## THE CHRISTIAN BIBLE TEACHING CHURCH SUBDIVISION

APPLICATION NUMBER 1 DATE February 7, 2008

REQUEST Subdivision

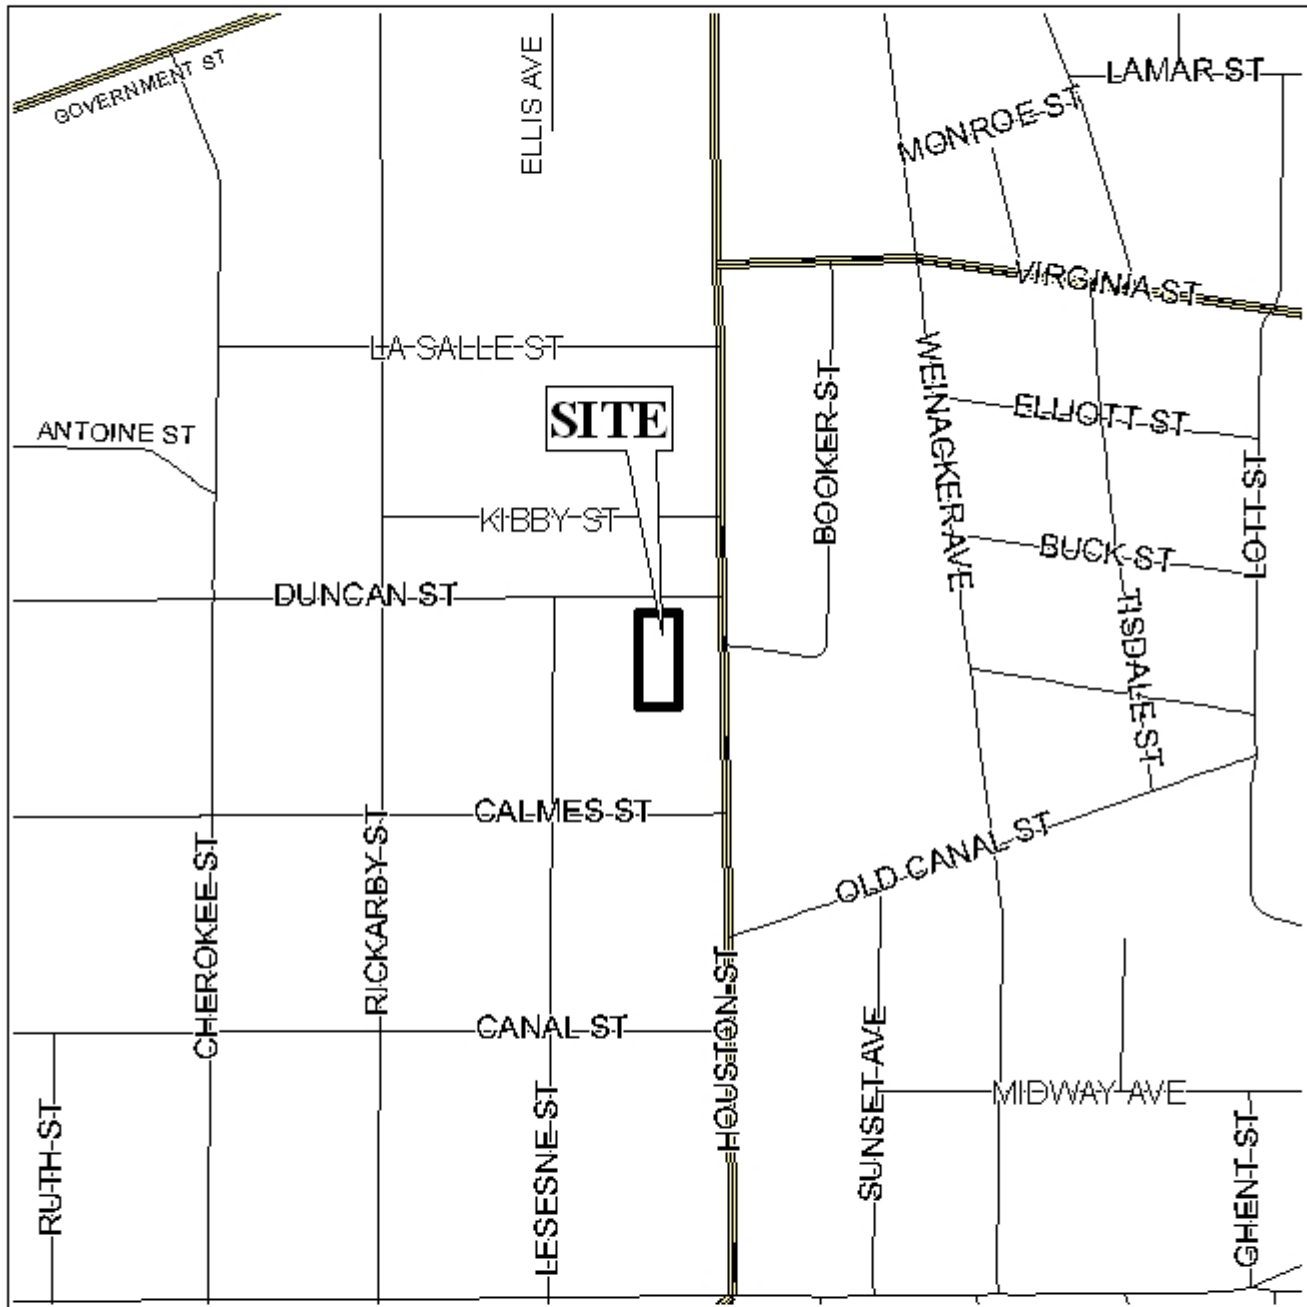
The plat illustrates the proposed 0.3± acre, one lot subdivision, which is located on the South side of Duncan Street, 70'± East of Houston Street in City Council District 3. The subdivision is served by city water and sanitary facilities.

The purpose of this application is to combine one legal lot of record and portions of two other legal lots of record into one legal lot of record.

No documentation was furnished concerning the date(s) that the portions of the other two adjacent lots were combined with the intact lot to form the current metes and bounds parcel. Also, the Planning staff has been advised by the property owner along the East of the subject site that the two sites share a common drive which is not indicated on the plat furnished. That fact, combined with the fact that the property to the East consists of one legal lot of record and the remaining portions of the two lots which were divided to become parts of the subject site, would necessitate a Planned Unit Development application for the two sites to share the common access, and would require the Eastern property as a second lot in this subdivision application.

Based on the preceding, this application is recommended for holdover to allow the applicant to:

- 1) submit a Planned Unit Development application for shared access with the adjacent property to the East;
- 2) revise this Subdivision application to two lots to include the adjacent property to the East; and
- 3) provide additional labels and postage for this application.
